South Texas Project Electric Generating Station 4000 Avenue F - Suite A Bay City, Texas 77414

January 14, 2010
U7-C-STP-NRC-100018

South Texas Project
Units 3 and 4
Docket Nos. 52-012 and 52-013
Response to Request for Additional Information

Attached are the responses to the NRC staff questions included in Request for Additional Information (RAI) letter number 297 related to Combined License Application (COLA) Part 2, Tier 2, Sections 3.8.1 and 3.8.5.

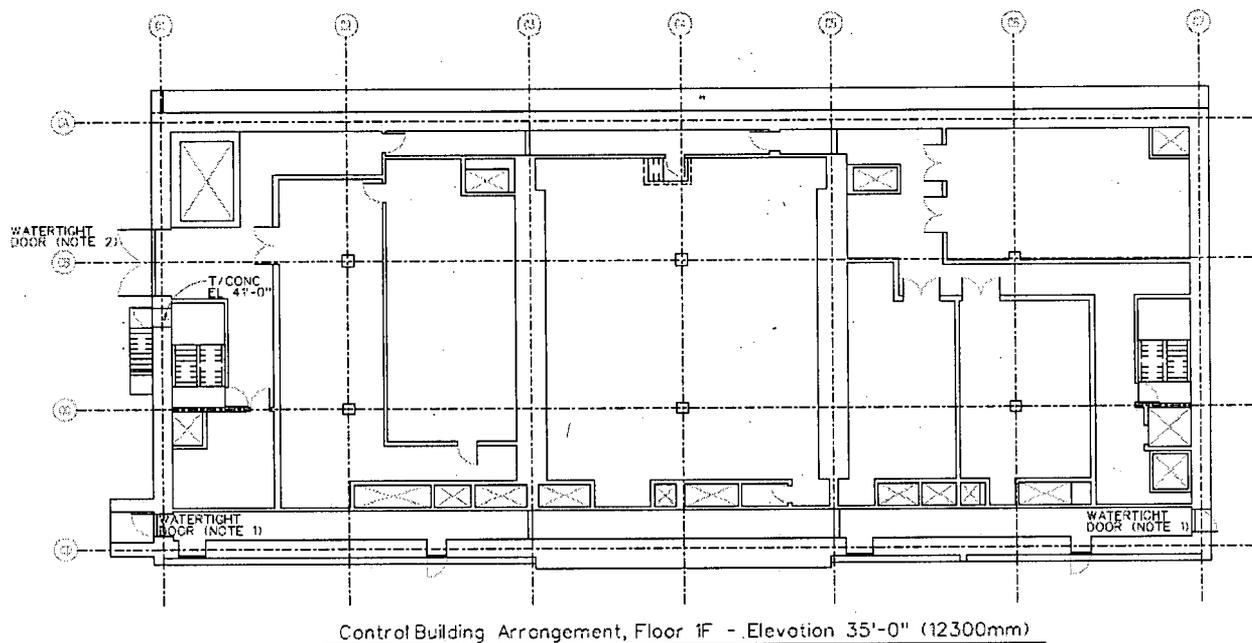
- (2) Identify the location of the additional watertight door between the Control Building and the Radwaste Building Access Corridor. This is not clear from the response to Question 03.08.04-3. Please identify the location of this door in a drawing.

- 1) COLA Part 2, Tier 2 Table 3.2-1 will be revised with a footnote added to the Reactor Building and Control Building rows to state that watertight doors which protect the safety-related equipment from an external flood are designated as Seismic Category I.
- 2) The attached sketch shows the additional watertight door between the Control Building and the Radwaste Building Access Corridor. Note that there is another exterior door by the stairwell shown on this sketch which does not need to be watertight because it will be located above the design basis flood level.

NOTES:
 1. WATERTIGHT DOOR NORMALLY OPEN.
 2. WATERTIGHT DOOR NORMALLY CLOSED.

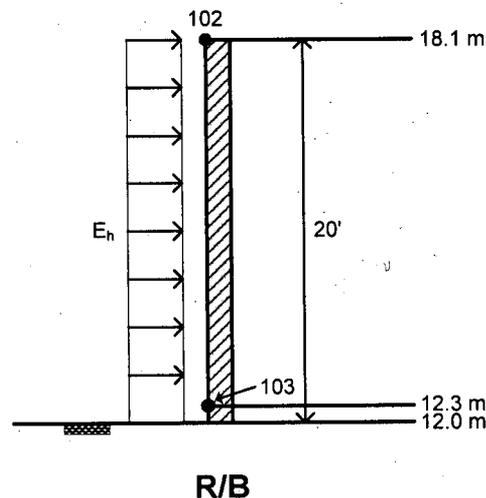
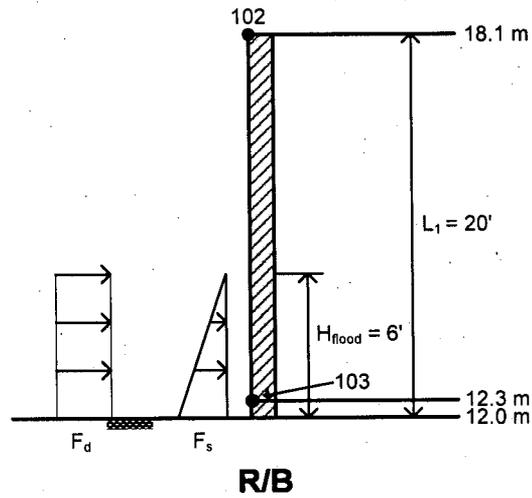
- (1) The applicant's response compares the out-of-plane shear and moment demands due to flood pressure with those due to the seismic load. The applicant did not include in its response any description or explanation about how the out-of-plane shear and moment demand for flood load and seismic load were obtained for the evaluation. Therefore, the staff requests the applicant to provide a detailed description of how the representative wall elements for the reactor building (RB) and the control building (CB) were selected for the evaluation, and how the reported shear and moment demands for flood and seismic load were determined.

(a) Reactor Building:

Design of exterior walls of the Reactor Building under safe Shutdown Earthquake (SSE) loading will have to accommodate both in-plane and out-of-plane seismic loads. For the above grade walls, the design-basis flood only affects the bottom 6 feet of the structure; thus, any in-plane load in the exterior walls due to design basis flood will be negligible in comparison to the seismic in-plane loads. However, when conservatively comparing the demand under seismic loading to the demand for flood loading, in-plane loads effect will be neglected and the comparison will be based on the demand for out-of-plane loads only. The parameters for determination of shear and moment demands for out-of-plane loads were as follows:

Simply supported wall span = 20 ft (see figure below, conservatively the span is assumed to be from grade to node 102, this will yield a more critical shear demand comparison)

Simply supported span = 20 ft
